Terminal connection changes:  
MCFB with single part connectors to new style MCFB3 with two part connectors.

**MTD MCFB3 T-B**

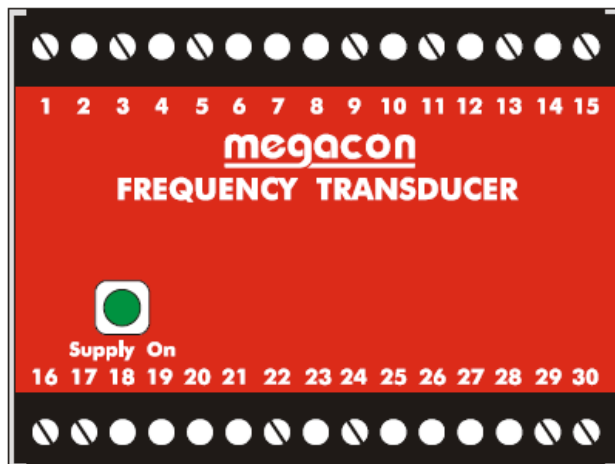
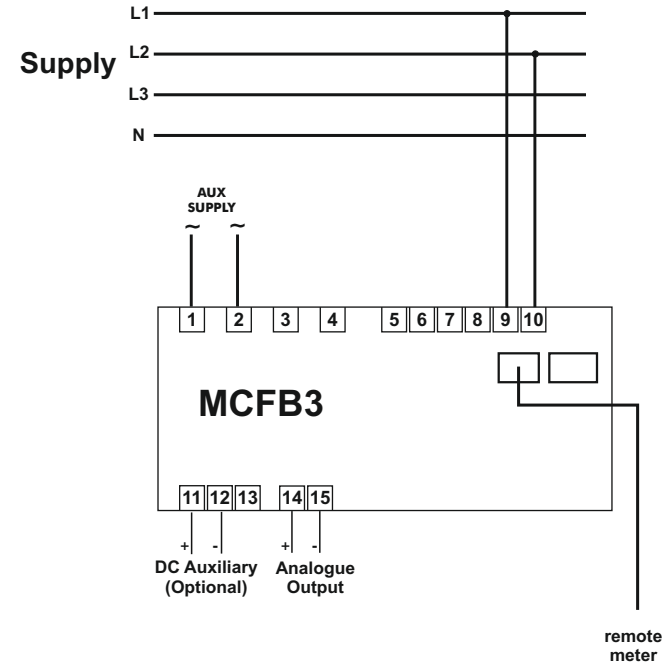
MCFB Terminal	MCFB3 Terminal
7	9
9	10
29	14
30	15
22	DC aux:11; AC aux: 1
24	DC aux:12; AC aux: 2
